The text reproduced below was prepared by the expert from the United Kingdom to insert into Regulation No. 13 a calculation method to ensure that the parking brake(s) on each side of the axle(s) are capable of providing their appropriate share of the braking force required to hold the trailer on an 18 per cent gradient. The modifications to the existing text of the Regulation are marked in **bold** characters.

A. PROPOSAL

Annex 12

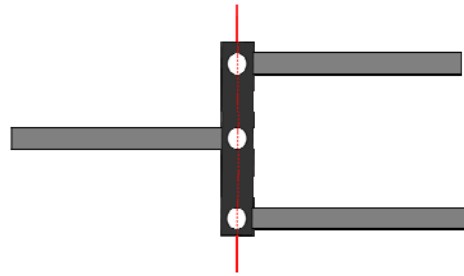
- 8.1.1. The pivot points in the compensator shall lie in a straight line with the park brake at the rest position.

All compensator pivots to be in-line

Alternative arrangements can be used, if they provide equal tension in both rear cables, even when there are differences in travel between the rear cables.

**"Figure 5A: MECHANICAL-TRANSMISSION BRAKING SYSTEM
(See paragraph 2.3. of this annex)**

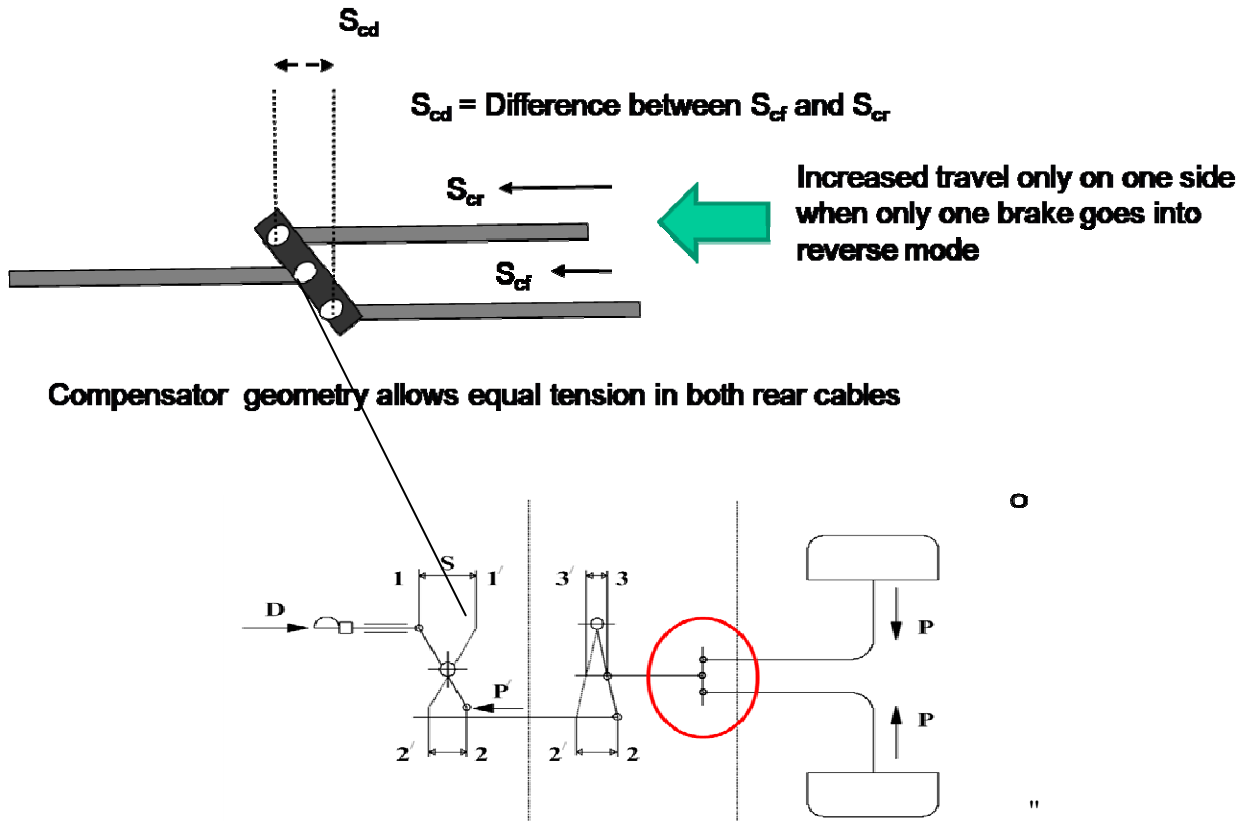
Where: $s_{cd} = s_{cr} - s_{cf}$ (see figure 5A Appendix 1)"

Appendix 1, insert a new figure 5A, to read:

Figure 1: Inappropriate design of compensator

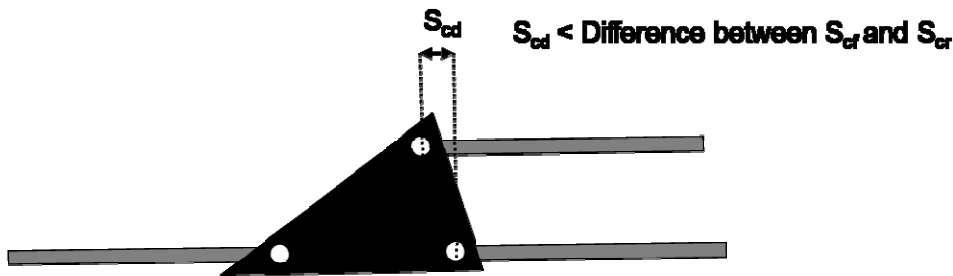
It is possible for a trailer braking system to comply with Annex 12, but to fail to operate correctly under certain circumstances. If the compensator is not designed correctly, then most or all of the tension is taken by only one of the rear cables and the other brake is no longer properly applied.

Compensator geometry provides limited articulation. Due to the difference in travel required in each cable, applied tension is only transferred to one side

Figure 2: Compensator operation

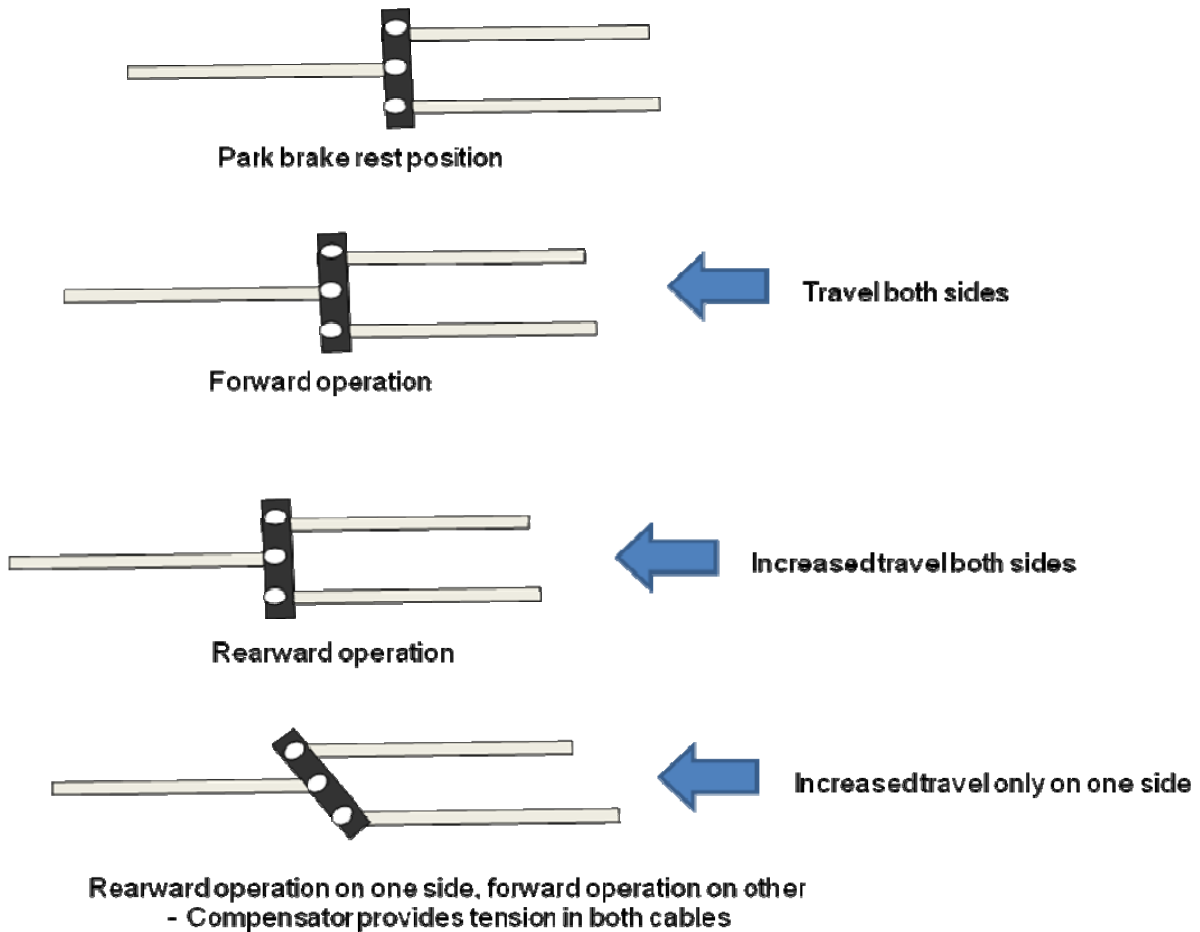
If the compensator design includes appropriate geometry, then both cables are subject to the same tension. Figure 2 shows the park brake operation of the compensator under various situations.

When the park brake is applied, the compensator applies tension to both rear cables. The compensator normally operates with either both brakes working in the forward or both in the reverse direction. However, if one wheel is stopped from moving by an external force (e.g. held against the kerb), then one brake can remain in the forward operating direction and the other will move into the reverse mode. This results in different travels in the left and right cables. The compensator must tilt to ensure that both cables are still held under the appropriate tension. This is shown in the last diagram in Figure 2.
